March 16, 2017

Re: Public Version of the Comments on NIPSCO's 2016 Integrated Resource Plan

The following comments on the 2016 Integrated Resource Plan submitted by Northern Indiana Public Service Company (“NIPSCO” or the “Company”) were prepared by Anna Sommer with Sommer Energy, LLC, and Elizabeth A. Stanton, PhD, with Applied Economics Clinic.¹ These comments were prepared for Citizens Action Coalition of Indiana (“CAC”), Earthjustice, Indiana Distributed Energy Alliance (“IndianaDG”), Sierra Club, and Valley Watch (collectively, “Commenters”) pursuant to the Indiana Utility Regulatory Commission’s (“IURC” or “Commission”) draft Integrated Resource Planning Rule, 170 IAC 4-7.²

Figure 1. NIPSCO 2016 IRP Figure 8-15: “Cost to Customer Impacts”

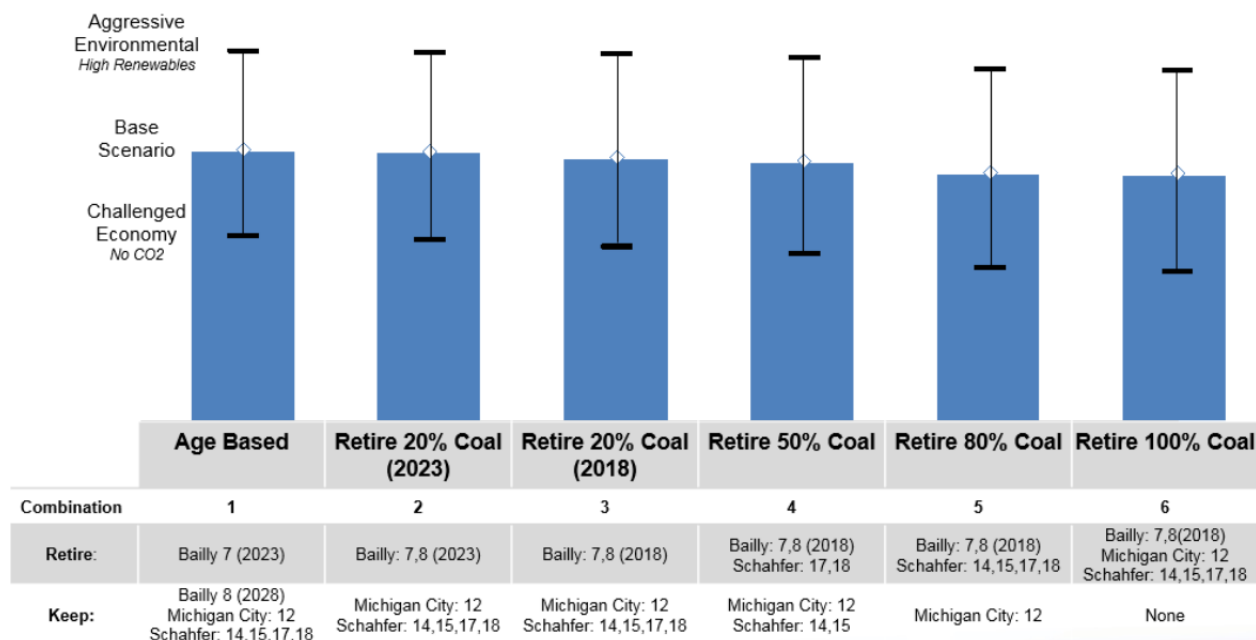
NIPSCO concludes that the least-cost option is to retire all of its coal generation but discards its own findings, in part, as a result of its IRP modeling's biased assumptions regarding replacement technologies for retired resources. NIPSCO fails to include any replacement resource other than a proxy capacity purchase price for a CCGT (not its MISO capacity purchase price) in its retirement analysis. This choice results in fewer retirements carried forward to later "optimizations" runs in NIPSCO's batched modeling process. Figure 1 reproduces NIPSCO's Figure 8-16 comparing the PVRR cost to customers across six retirement portfolios and a "wide range of scenarios" (NIPSCO 2016 IRP, p.137); the height of the blue columns is the portfolio PVRR modeled in the Base Case scenario and the vertical "whiskers" represent the range of PVRR results across NIPSCO's full set of modeled scenarios.

Retiring 100 percent of coal generation has the lowest cost to customers (with a difference in PVRR over 20 years from NIPSCO’s preferred Retire 50% Coal plan of \$581 million) and also has the lowest emissions (see NIPSCO 2016 IRP, Figure 8-17). The “Retire 100% Coal” plan, however, scores poorly in NIPSCO’s assessment of “portfolio diversity,” “employees,” and “communities and local economy” and is not chosen as NIPSCO’s retirement plan used in modeling (see Figure 2):
